CIVIL AND STRUCTURAL ENGINEERING SERVICES, PLLC STATEMENT

ARCHITECTURAL PLANS ARE WERE PREPARED BY OTHERS. CIVIL AND STRUCTURAL ENGINEERING SERVICES PROVIDED STRUCTURAL ENGINEERING DESIGN REVIEW SERVICES. THE PROFESSIONAL SEAL AND SIGNATURE AFFIXED BELOW CERTIFY THAT PLANS AS MARKED/NOTED MEET LOAD BEARING REQUIREMENTS OF NORTH CAROLINA BUILDING CODE, **RESIDENTIAL 2018**

000	Sheet index							
000 001	Cover Notes							
101-A								
101-S								
201 301	Schedules Elevations							
302	Elevations							
401	Foundation Layout							
501	Panel Layout							
601	Roof Framing Layout							
701 702	Building SectionsBuilding Sections							
702	Wall Sections							
704	Wall Sections							
705	Details							
No.	Description Date							
0	Initial Plans 5.4.22							
1	Release 5.18.22							
	Evans							
Ridgeline - B South								
Job Nu								
	Drawing Number 22RI-098							
Project Manager SG Drafter JC								
Diaiter	JC							
Cover								
	000							
Scale

Wall Sections

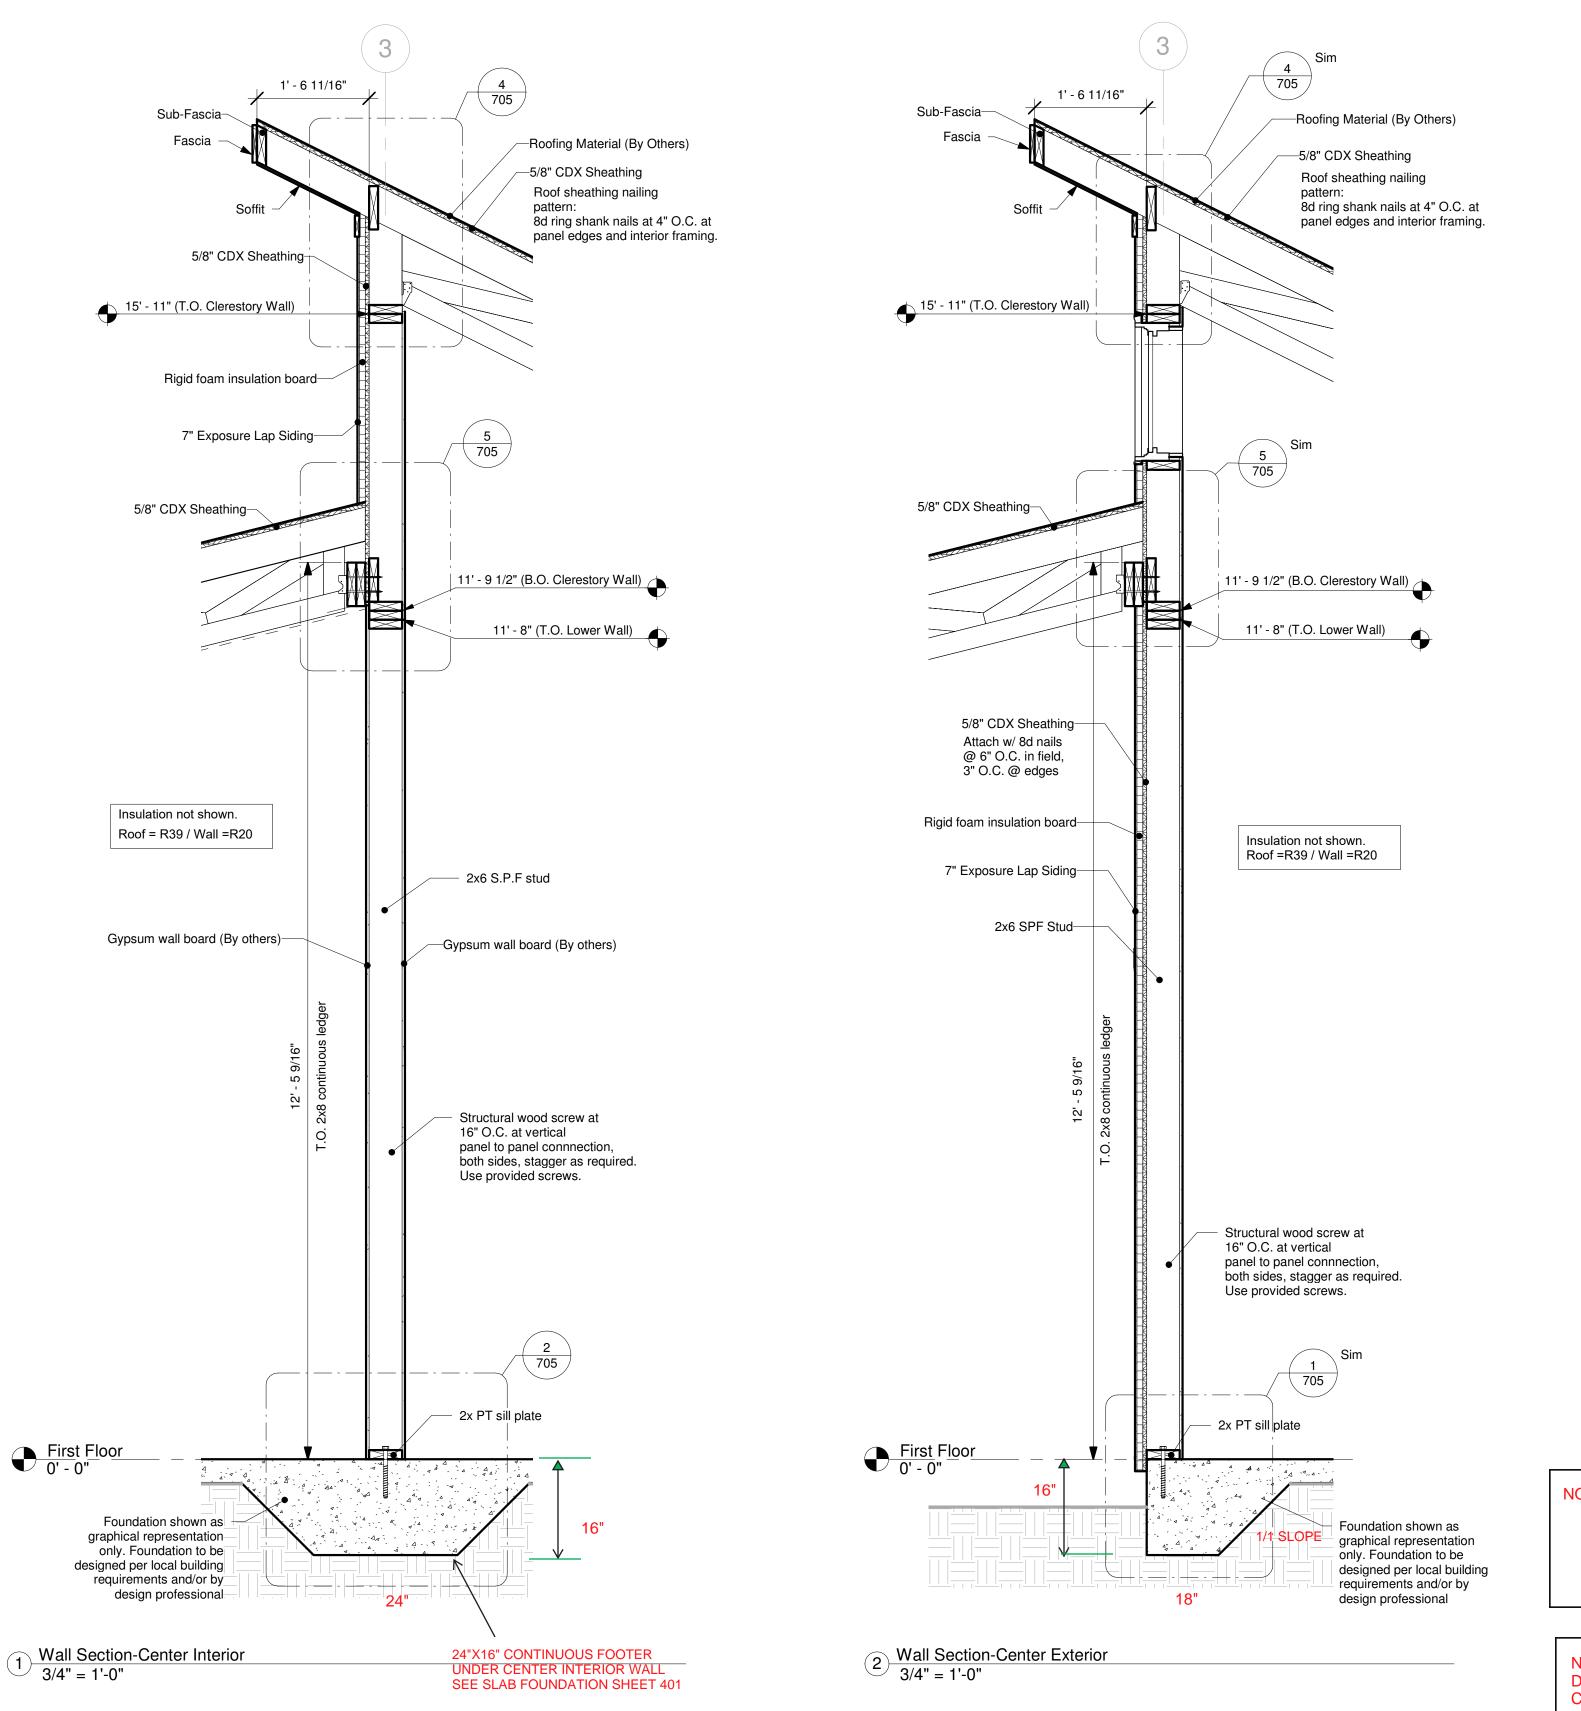
NOTE: FOUNDATION SLAB SHALL BE CONSTRUCTED AS FOLLOWS: 4" CONCRETE SLAB 3000 PSI STRENGTH WITH FIBERGLASS REINFORCEMENT OVER MIN 6 MIL VAPOR BARRIER OVER 4" WASHED CRUSHED STONE 67 OVER MECHANICALLY COMPACTED EARTH. VIRGIN UNDISTURBED SOIL SURFACE IS ACCEPTABLE

NOTE: FOOTERS SHALL BE CONTINUOUS ALONG THE OUTSIDE PERIMETER OF THE SLAB DIMENSIONS OF FOOTERS SHALL BE AS SHOWN ON THE PLAN SECTIONS. FIBERGLASS CONCRETE WITH 3000 PSI STRENGTH IS PERMISSIBLE.

NT	deltec homes
	No. Description Date
	No.DescriptionDate0Initial Plans5.4.221Release5.18.22
	Evans
	Ridgeline - B South
	Job Number22031Drawing Number22RI-098Project ManagerSGDrafterJC
	Wall Sections
	704

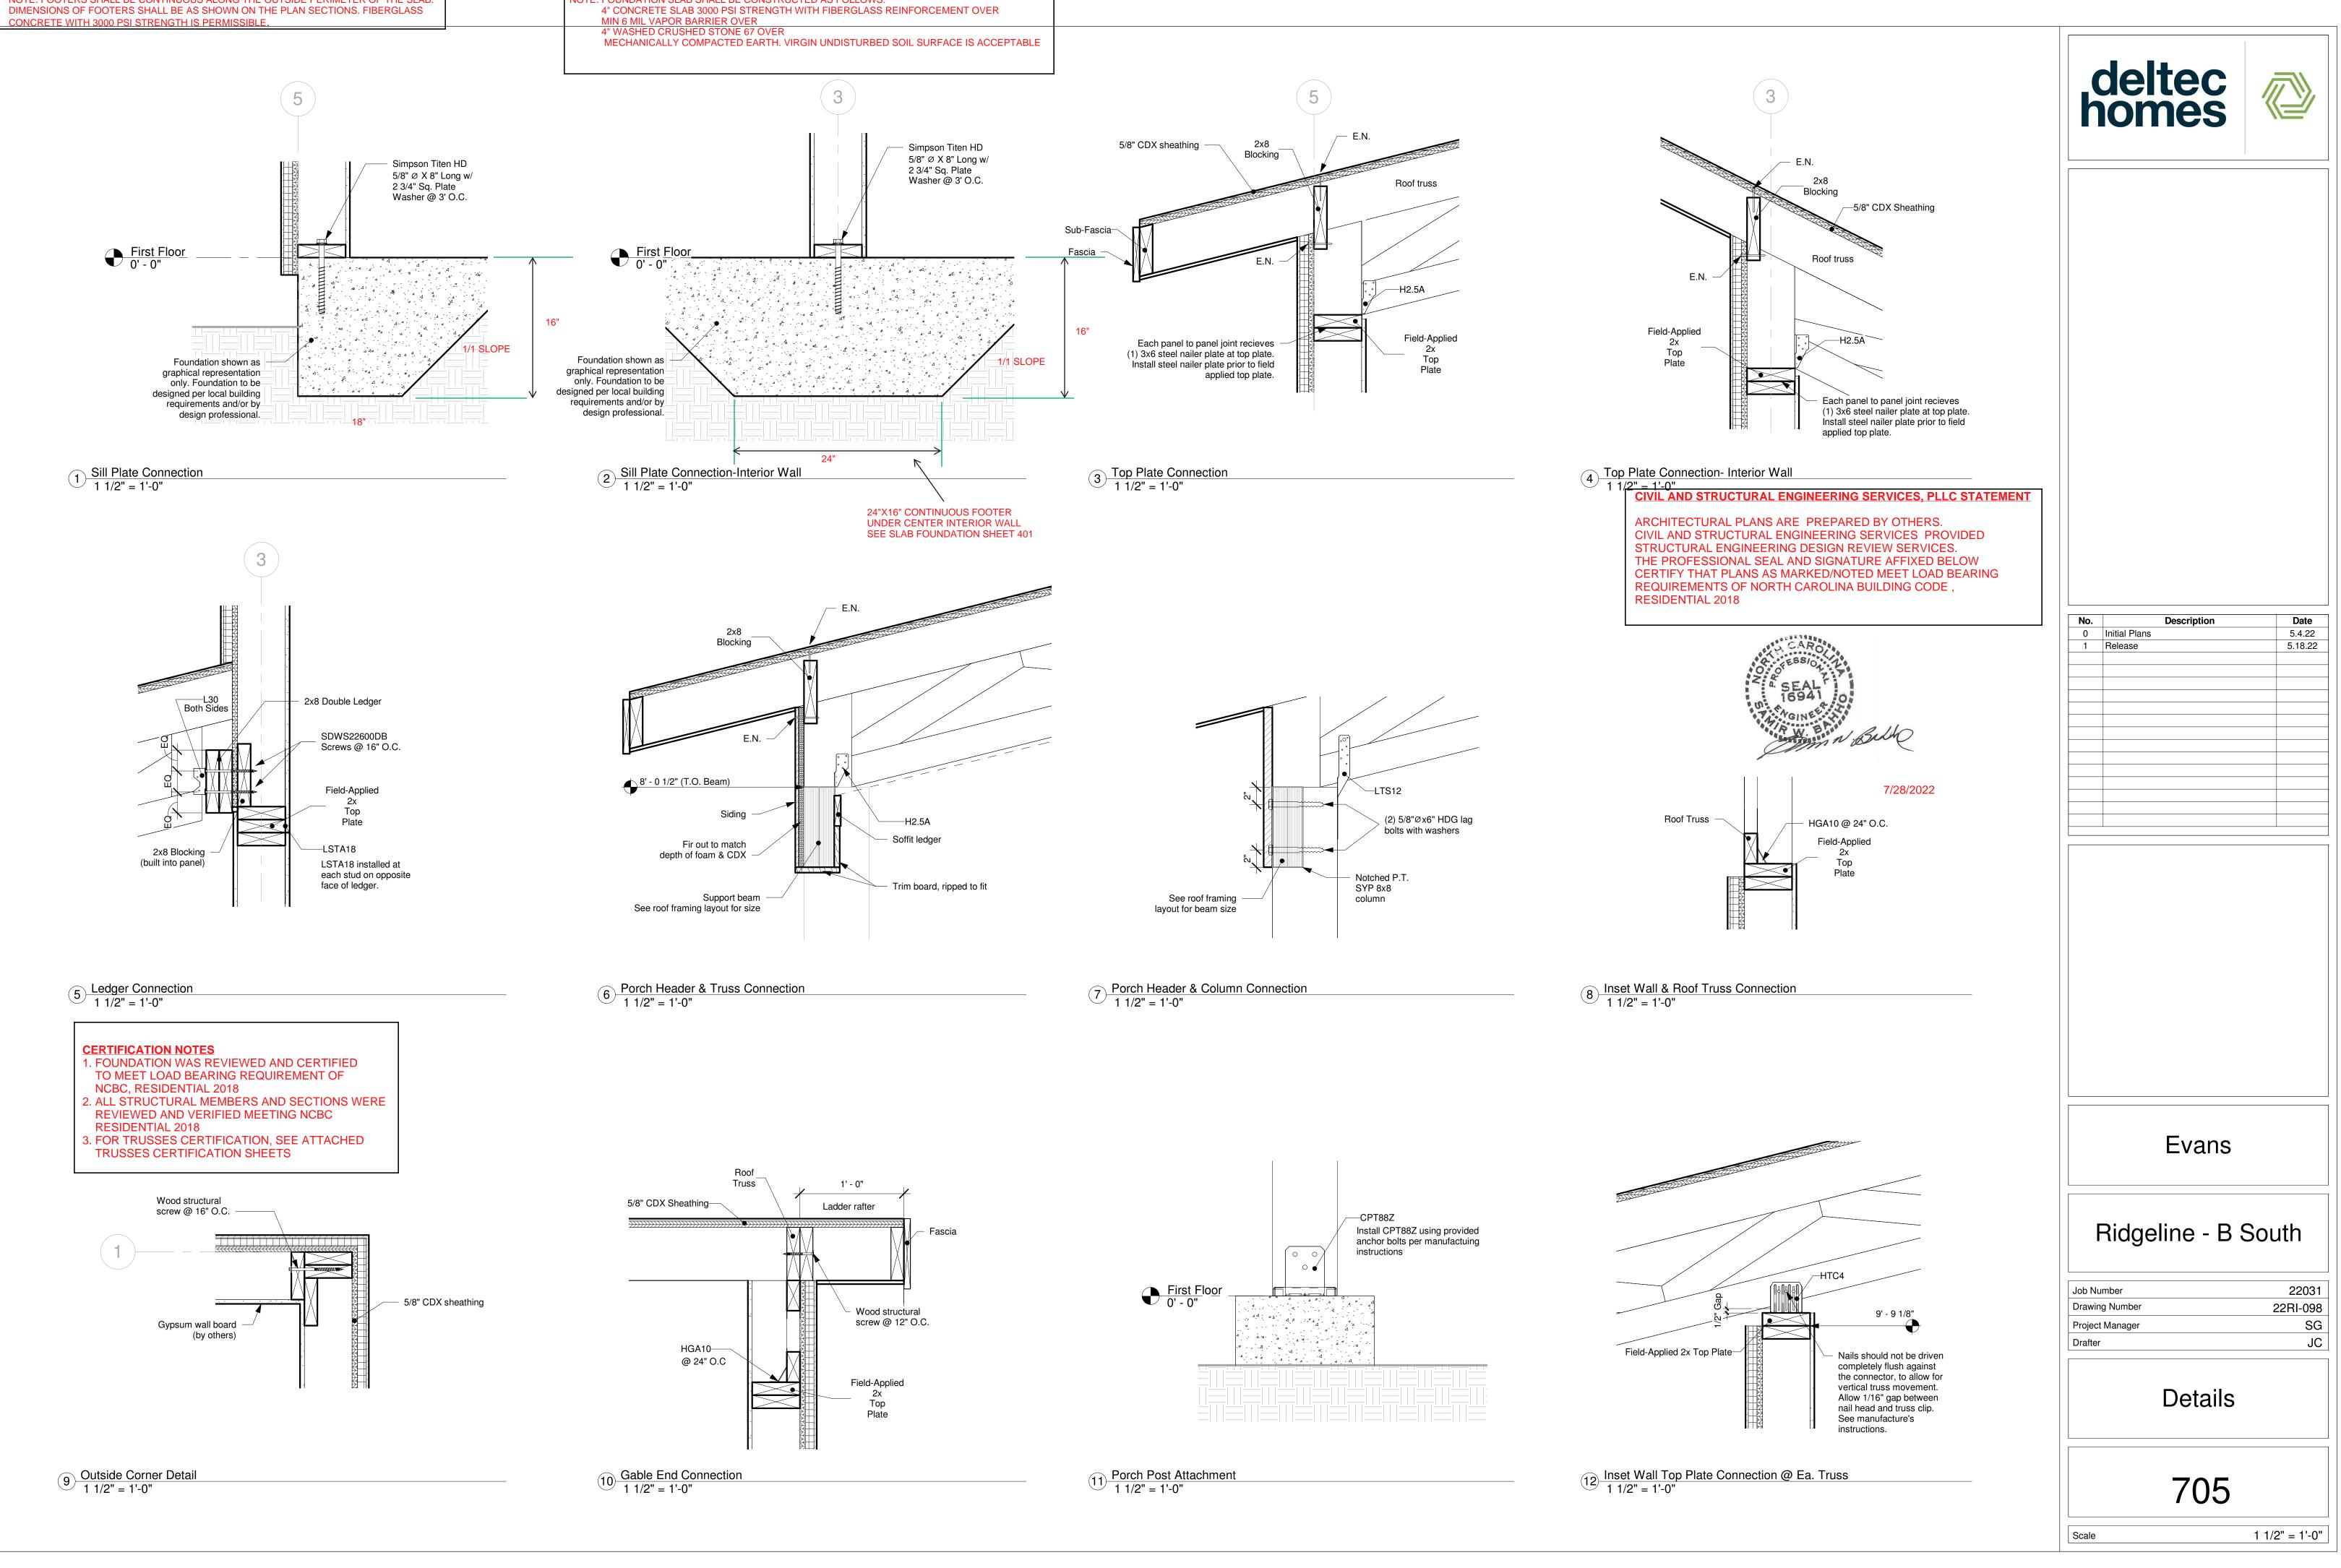
NOTE: FOOTERS SHALL BE CONTINUOUS ALONG THE OUTSIDE PERIMETER OF THE SLAB. DIMENSIONS OF FOOTERS SHALL BE AS SHOWN ON THE PLAN SECTIONS. FIBERGLASS

NOTE: FOUNDATION SLAB SHALL BE CONSTRUCTED AS FOLLOWS:
